SB, Fuel Hose Contact with Rear Tire, Poulan Pro Zero Turn Mowers Equipped with Briggs & Stratton Twin Cylinder Engines, P54ZX, 2017-12

Service Bulletin B170066C-14

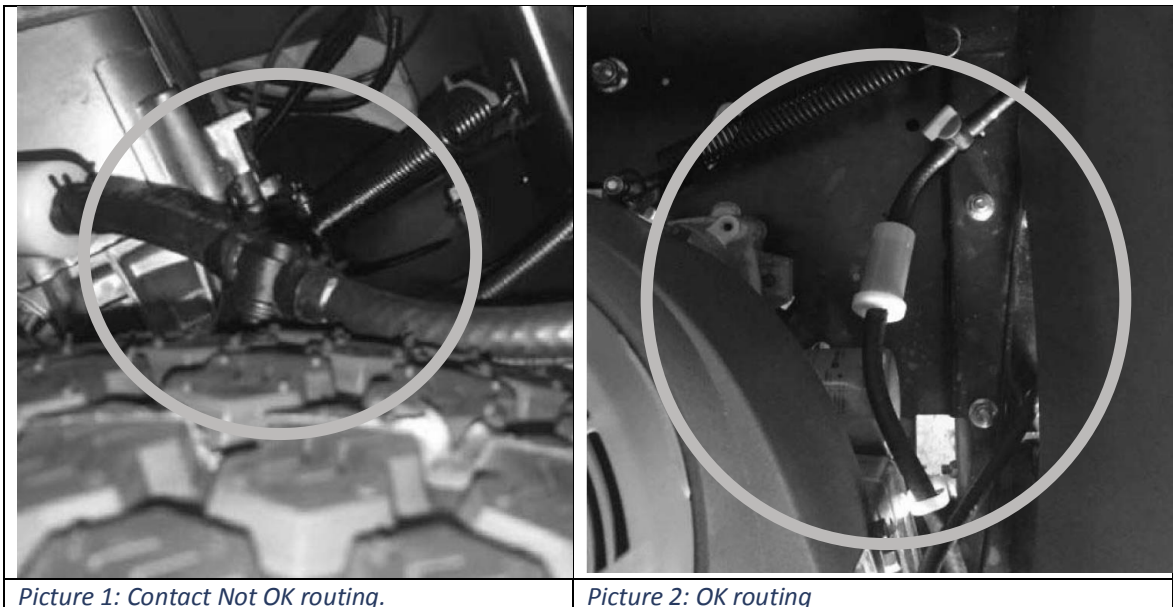
Routing of the fuel hose can potentially result in contact between the fuel hose and the right rear tire. Contact may result in rubbing and abrasion of the fuel hose, which creates the potential for leakage of fuel.

- Step 1.** Using a flashlight, check the position of the fuel hose. The picture on the left shows incorrect routing where fuel hose contacts the Right Rear Tire (Picture 1). The picture on the right (Picture 2) shows the correct routing where fuel hose is positioned on the engine plate away from the tire.

- Step 2.** Check fuel hose for damage. If any damage is observed, replace fuel hose assembly.

Note: If fuel hose has no damage and routing is correct, service is not required.

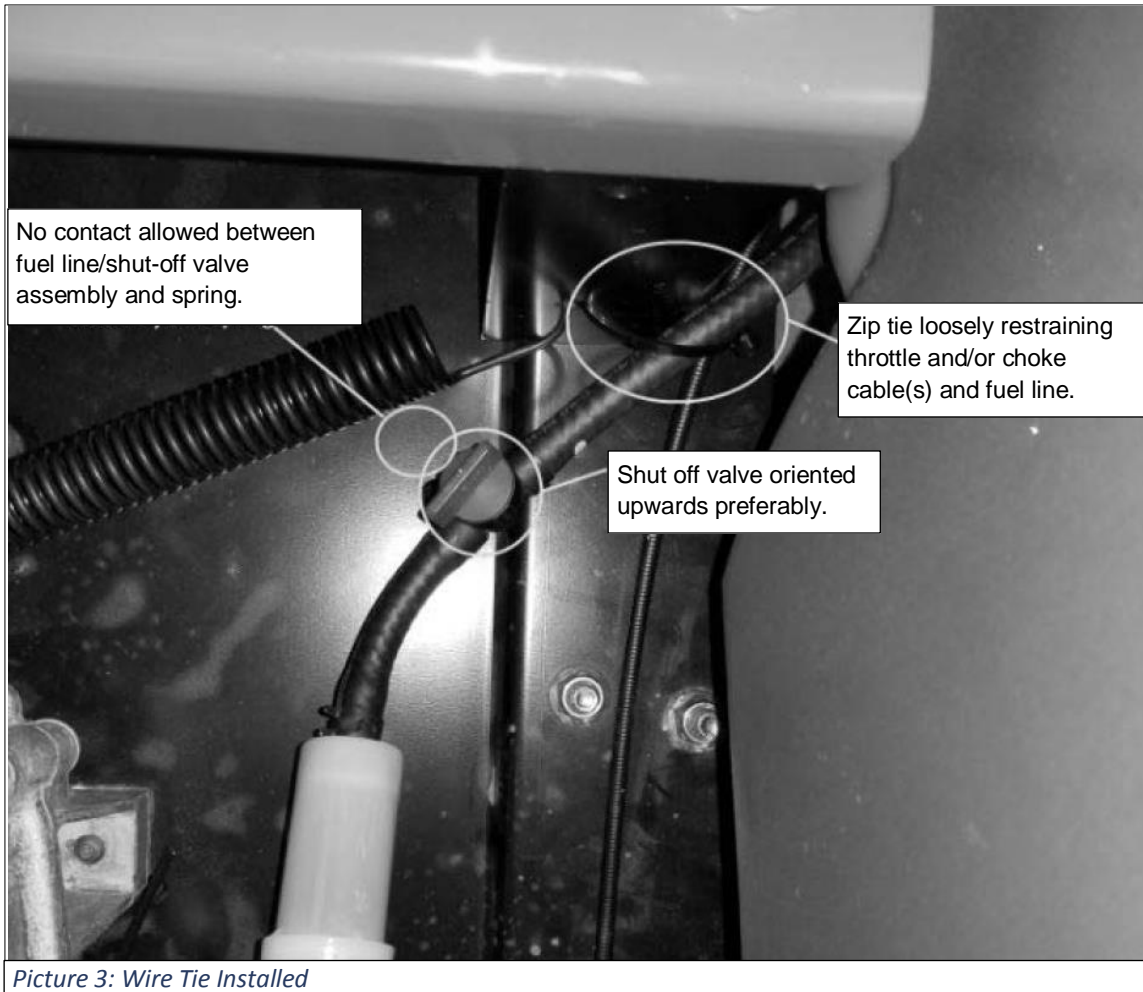
- Step 3.** If routing is incorrect, route fuel hose near seat support and loosely secure the fuel hose to the seat support with a wire tie. See Picture 3.
